NUREG-1338

Draft Preapplication Safety Evaluation Report for the Modular High-Temperature Gas-Cooled Reactor

U.S. Nuclear Regulatory Commission

ABSTRACT

Figure 4.5 Potential TRISO-coated fuel-particle-failure mechanisms
Source: Neylan, 1988-1

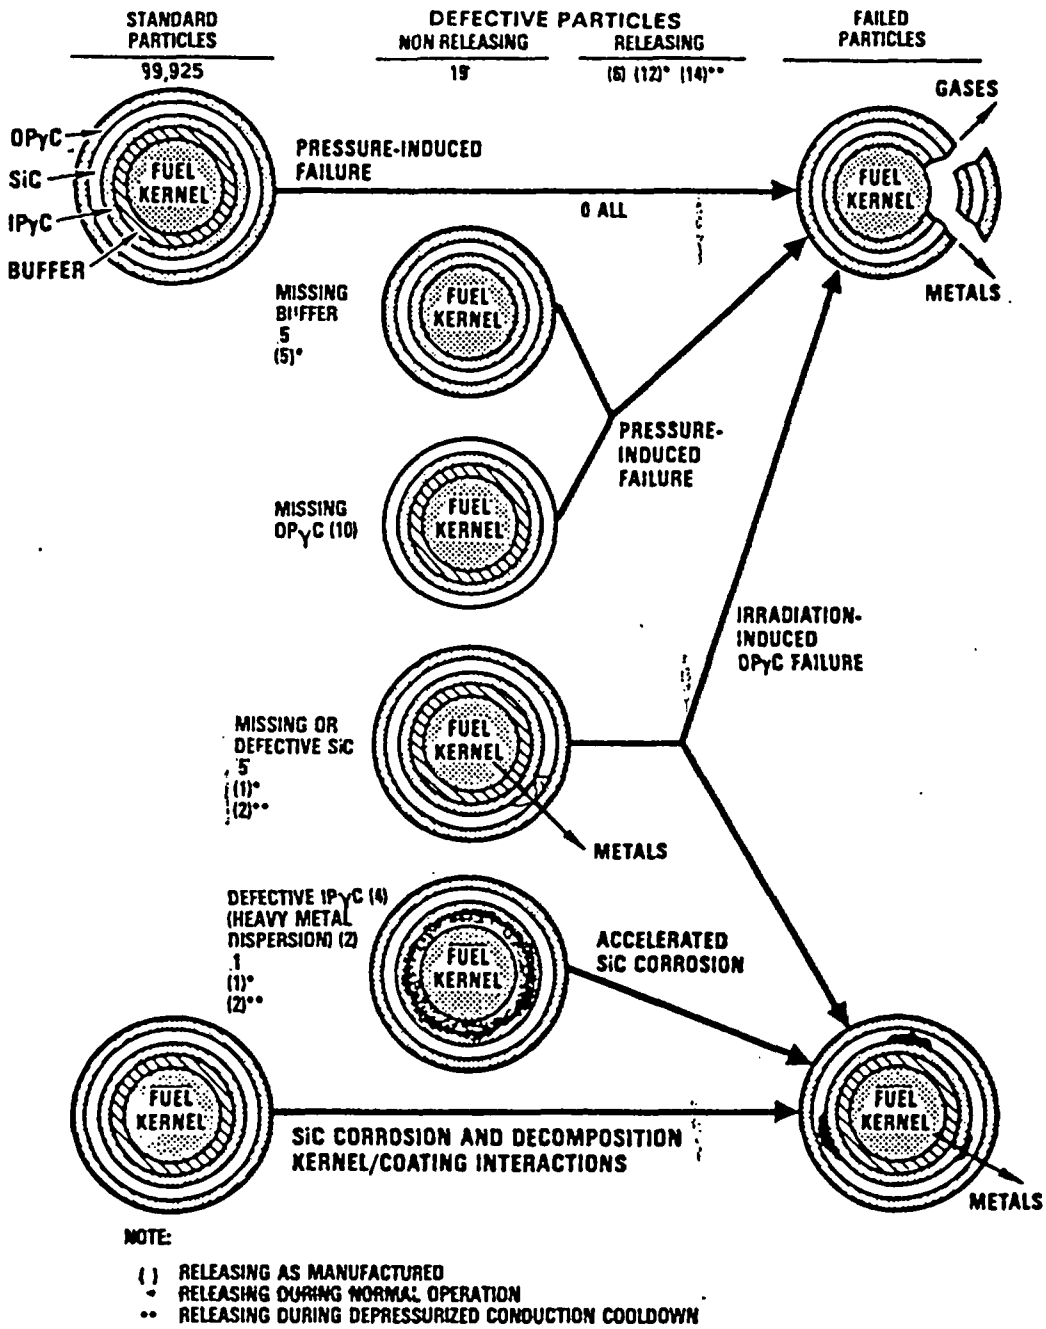
Figure 4.5 does not show the fuel-failure mode by hydrolysis of the fuel kernel for those particles that have a missing silicon carbide layer or failure modes that could be caused by steam, water, or air ingress or other chemical attacks. This augmented release of fission products would occur if the helium coolant should contain significant trace levels of moisture or induction of steam, such as would follow a steam generator tube failure at operating temperatures.

Figure 6.1 Plant building arrangement
Source: DOE, 1986-3

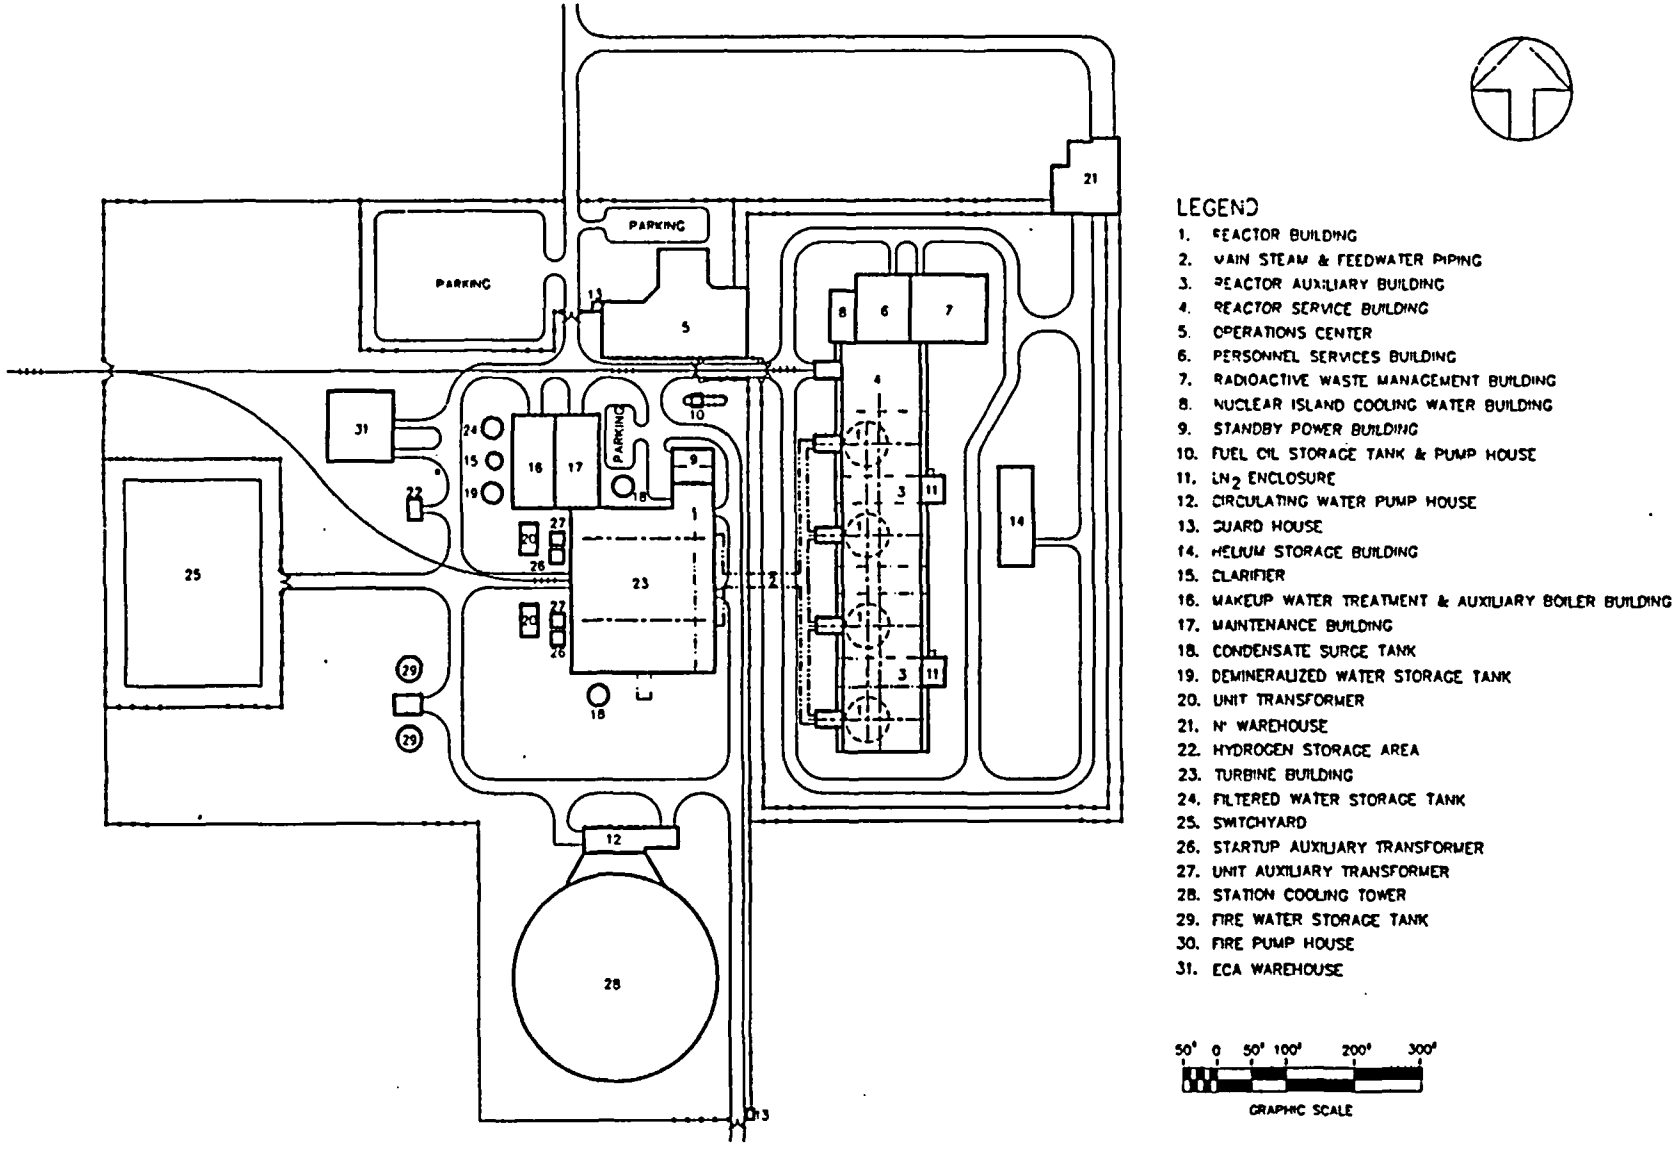
The conceptual design plot plan (see Figure 6.1) includes two fences surrounding the NI protected area. In Comment 13-10, the staff asked for confirmation that one of these two fences was not intended to be the vital-area barrier. The response from DOE did not preclude the use of fences as vital-area barriers. This would be unacceptable. The NRC regulatory position, as presented in Regulatory Guide 5.65, is that:

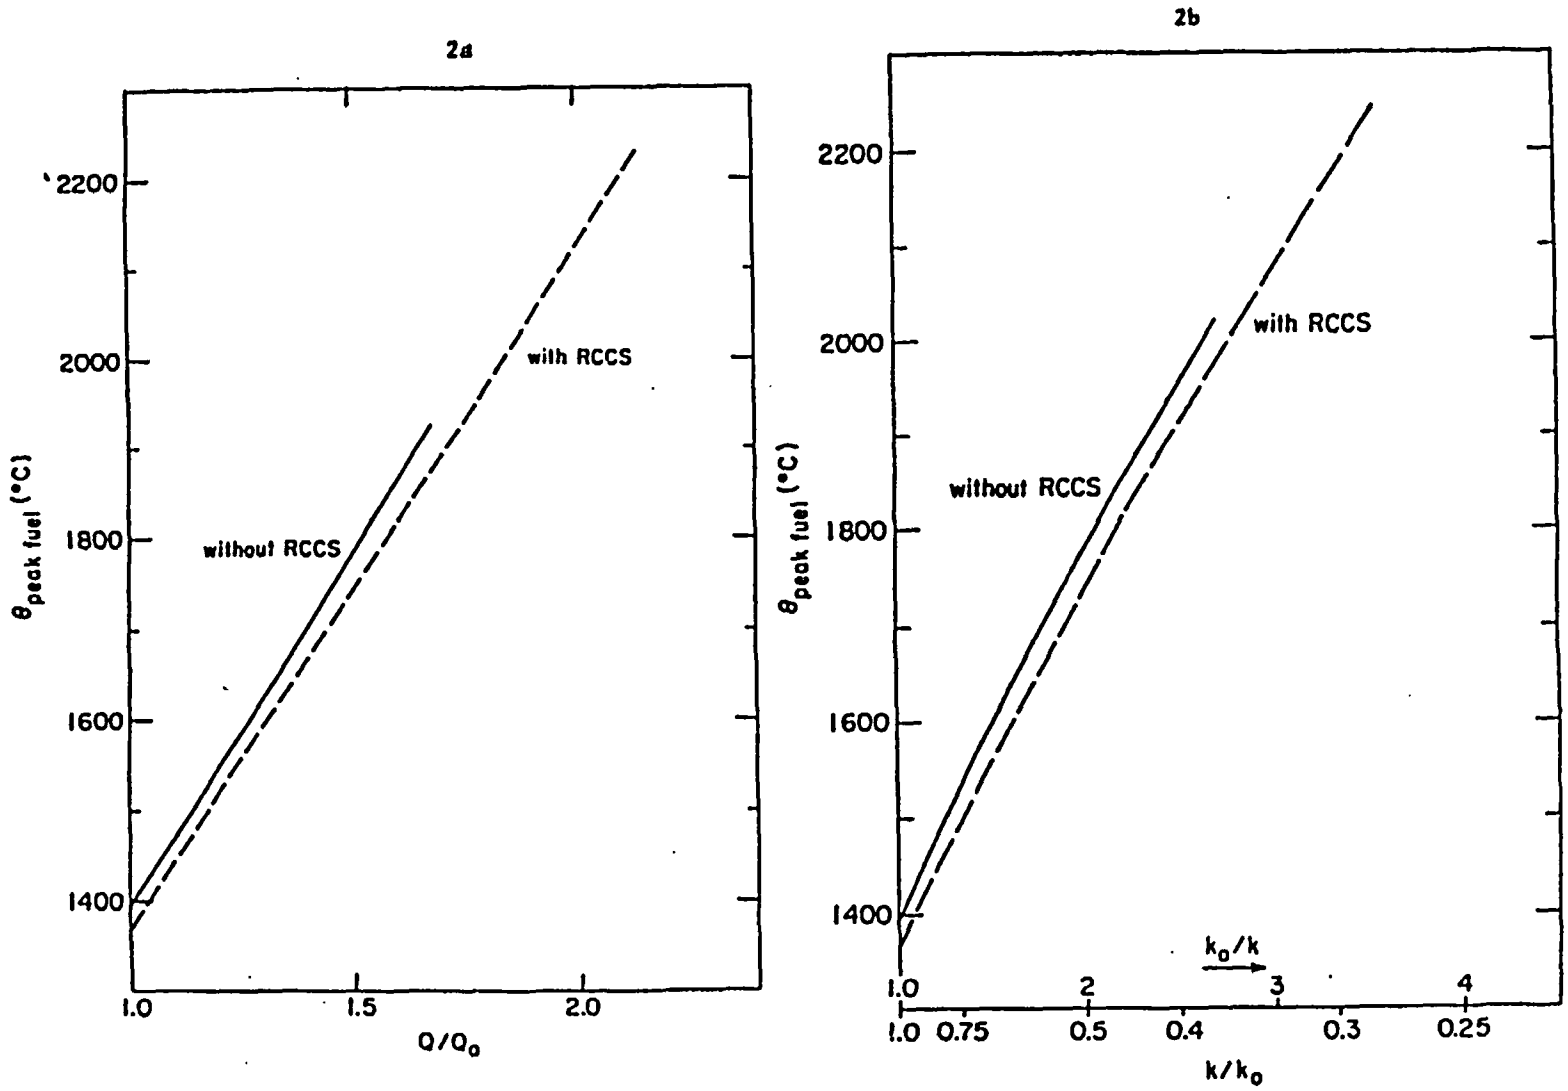
The results in Figure 2 show that a 30% increase in decay heat or a 37% reduction in effective thermal conductivity would be required in order to reach 1600°C peak fuel temperatures. Significantly larger margins exist before the 2200°C threshold would be reached. A 27% increase in decay heat was found to cause peak vessel temperatures of 480°C, the value beyond which the restart capability of the vessel might be compromised. Thus, in operation with RCCS, significant performance margins exist before fuel failures and additional fission product release would be expected. However, the evaluations show that a high confidence in the decay heat function and effective core thermal properties is required to assure that vessel temperatures do remain within safe bounds.

corresponding cases with RCCS as shown in Figure 2: a 27% increase in decay heat and a 33% reduction of the core effective thermal conductivity were required to reach peak fuel temperatures of 1600°C. However, unacceptable vessel and concrete temperatures are possibly reached. A 40% increase in decay heat brings the peak vessel temperature to 1000°C (however, only after 6 weeks). While there is no specific vessel failure temperature or failure mode, mechanistic accident scenarios can be envisioned here, during which some fuel failures occur around 100 hr, and subsequent vessel failures occur after several weeks, when core temperatures have already returned to the 1200 to 1300°C range.
